# ESTABLISH RWY 7 ROLLOUT RVR PHASE I BARROW, ALASKA FOR CONSTRUCTION

## PHASE I SCOPE

CHANGED SOURCE OF POWER TO EXISTING FAA-OWNED TRANSFORMER.  
DATE OF REVISION: 4/2/2012

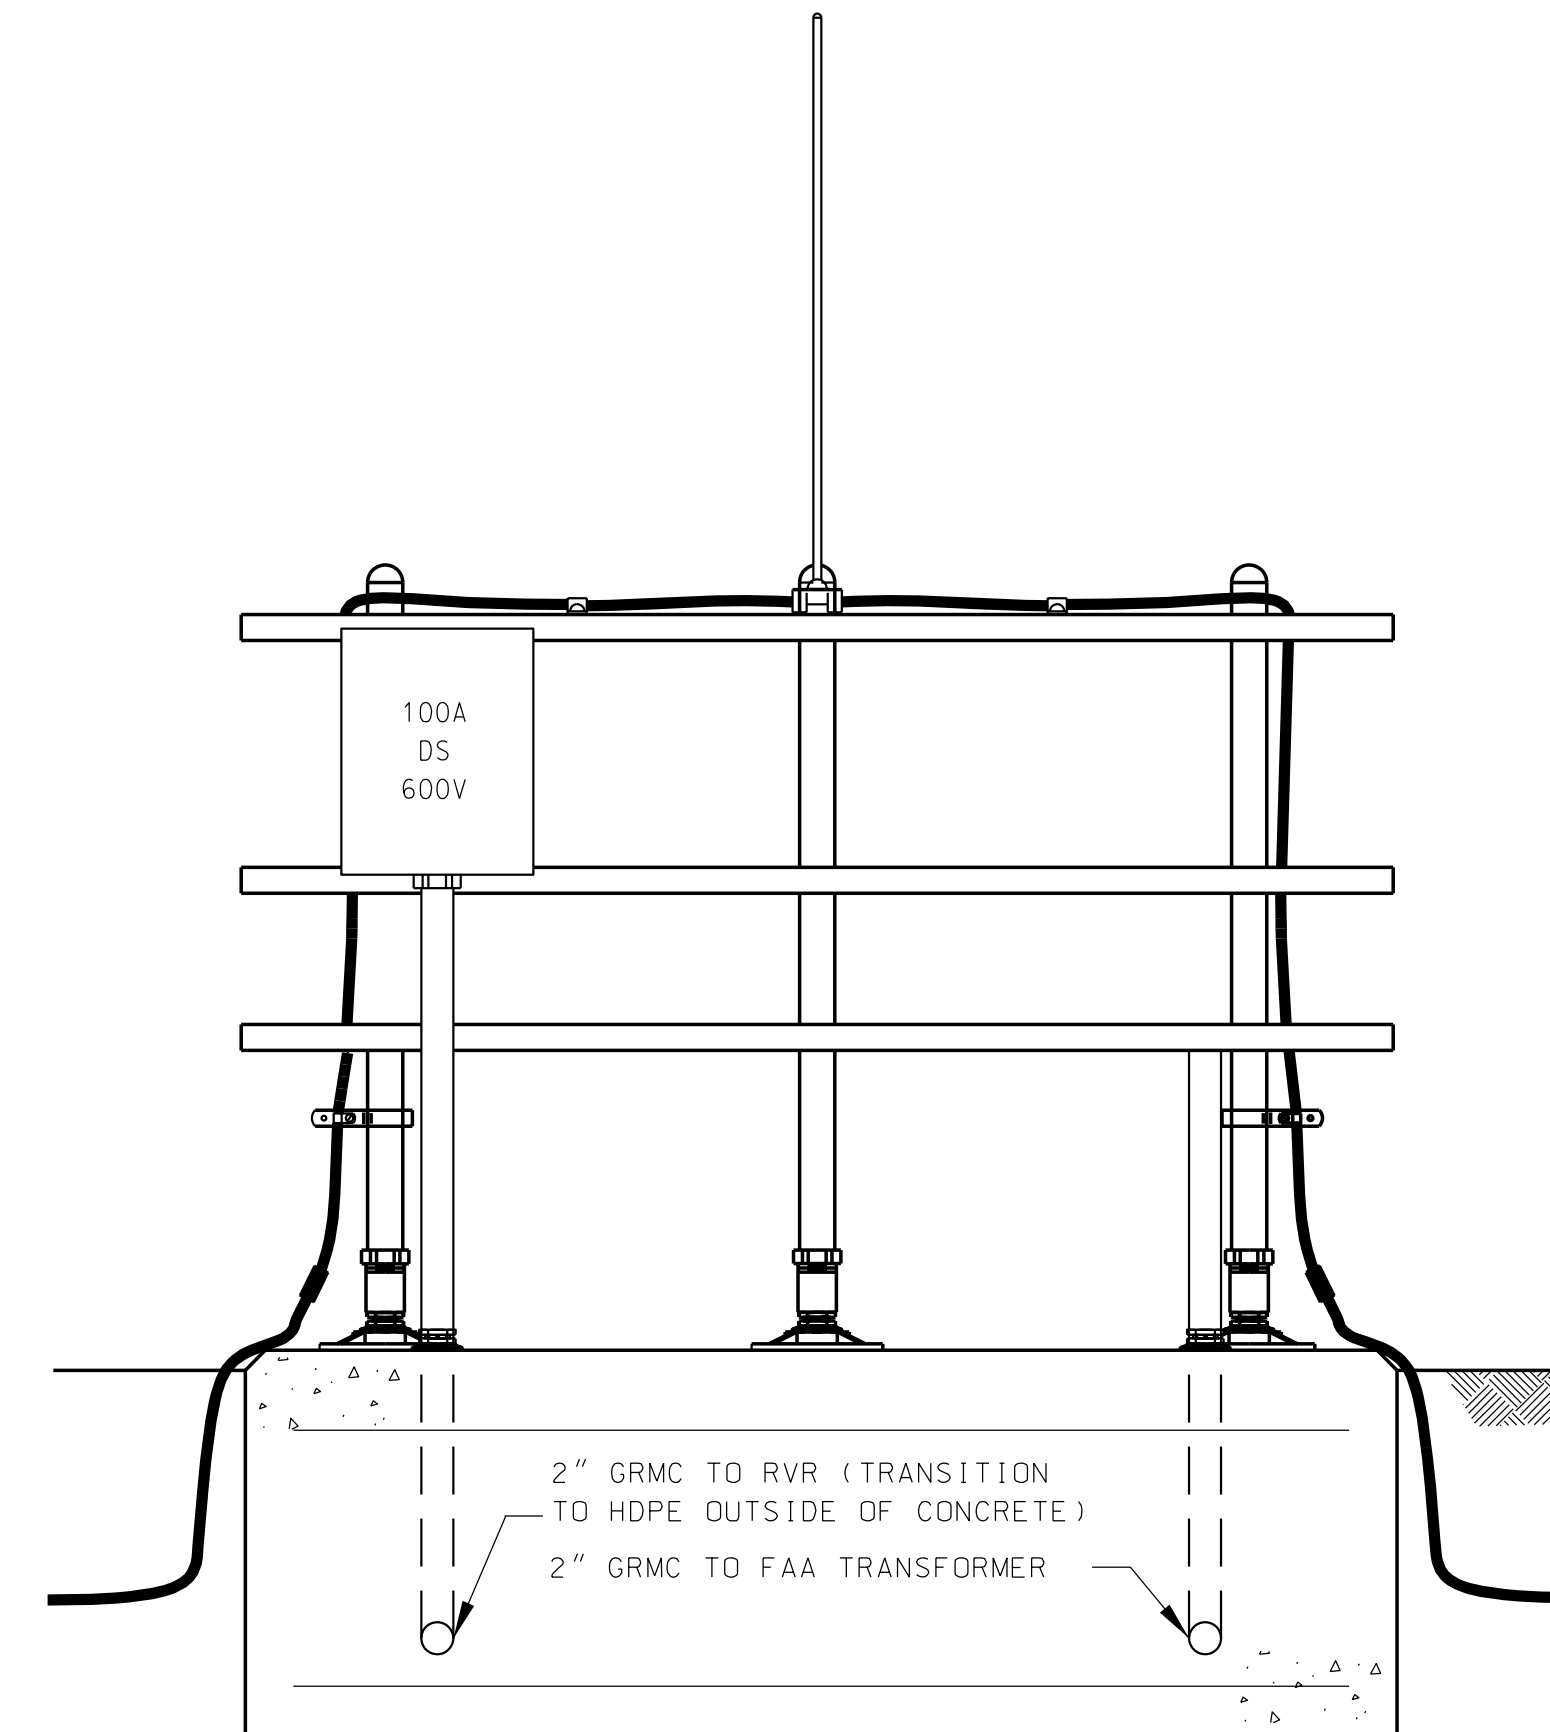
△ REMOVED METERBASE ENCLOSURE.  
DATE OF REVISION: 4/2/2012

ONE-LINE DIAGRAM

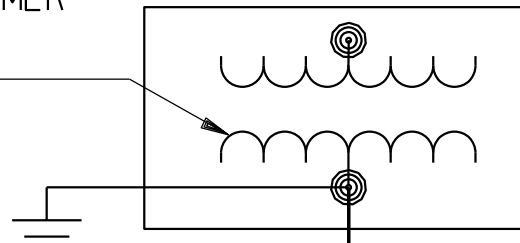
REMOVED METERBASE ENCLOSURE.  
DATE OF REVISION: 4/2/2012
